HISTORIC AND DESIGN REVIEW COMMISSION

April 20, 2016

HDRC CASE NO: 2016-147
ADDRESS: 300 SAN FERNANDO ST
LEGAL DESCRIPTION: NCB 306 BLK 10 LOT 23 LA TRINIDAD UNITED METH CH
ZONING: I1 HS
CITY COUNCIL DIST.: 5
LANDMARK: La Trinidad United Methodist Church
APPLICANT: Accu-Rite Roofing and Construction Services
OWNER: La Trinidad United Methodist Church
TYPE OF WORK: Window enclosure

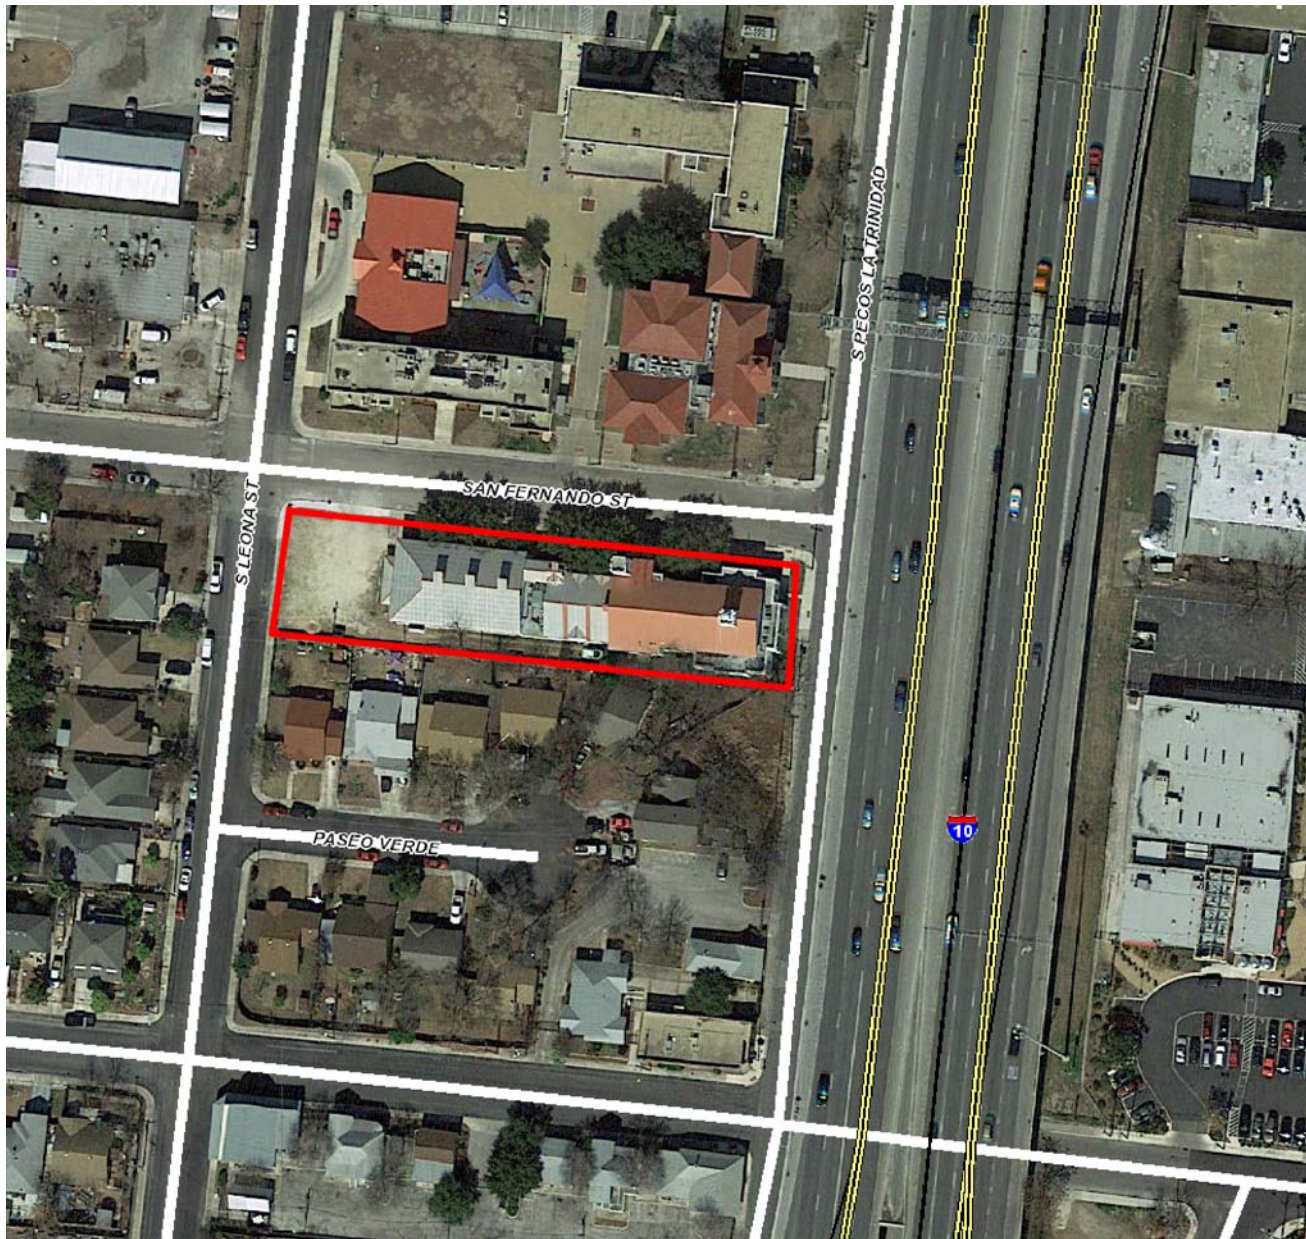
- a. The applicant is proposing to replace 6 windows on the east façade with glazed terracotta tiles in a 3 by 4 configuration. The tiles along the bottom row will be cut to fit the size of the window. The tiles will be recessed and all joints will be 1.5” thick and have a uniform appearance.
- b. La Trinidad United Methodist Church is a local landmark. The 1921 historic photo indicates the window openings

on the east facade are original. According to the Guidelines for Exterior Maintenance and Alterations 6.B., original window openings should be maintained.

- c. Staff finds that extensive alterations have change the character of this local landmark, the proposal does not adversely affect the historic structure, and the proposal is also reversible.

Staff recommends approval based on findings a through c with the stipulation that the tiles be recessed 1 to 2 inches.

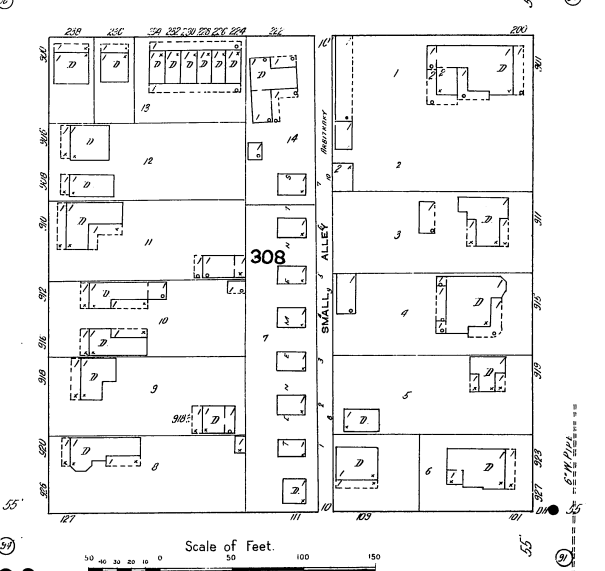
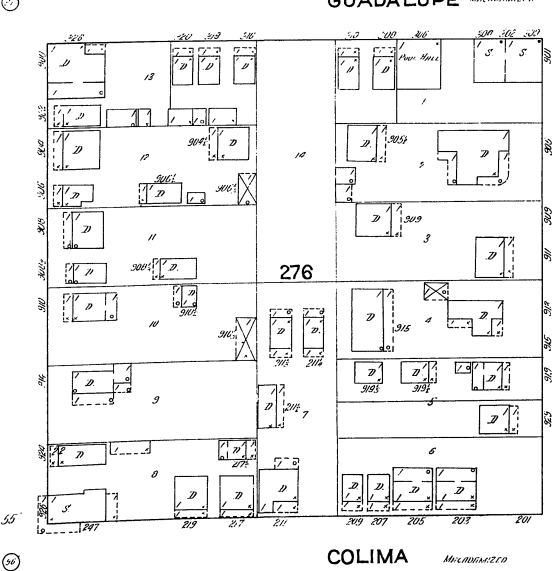
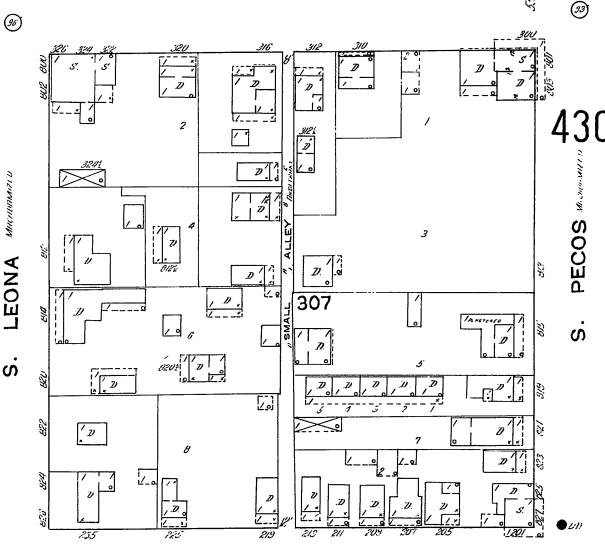
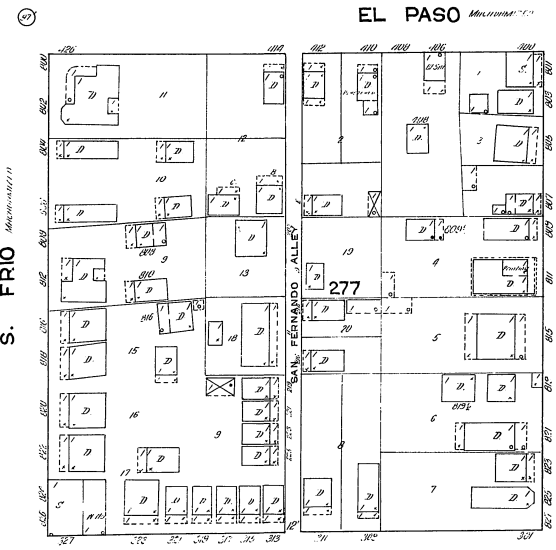
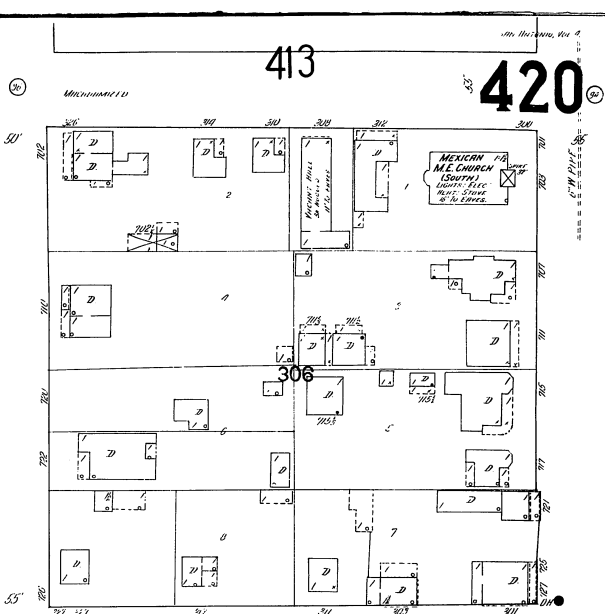
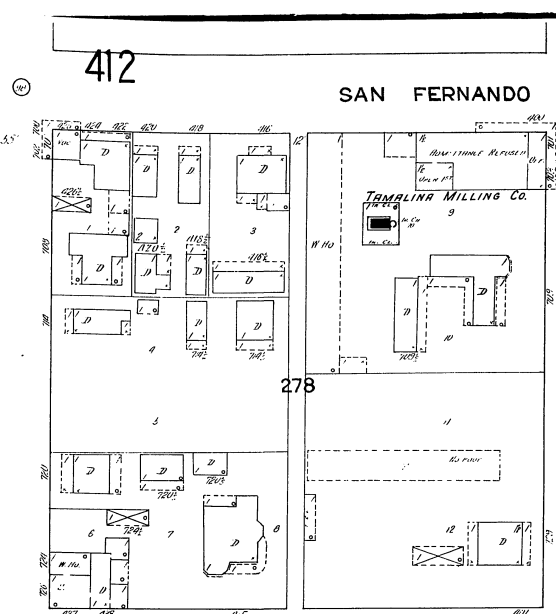
All joints will be 1 1/2" thick and have a uniform appearance

1. Cinder block concrete 8x8x16 back filled with concrete and set in mortar.
2. Textured concrete trowel grade.
3. Interior latex primer and paint satin sheer.
4. 12"x12" tile set in grout joints color to match tile.
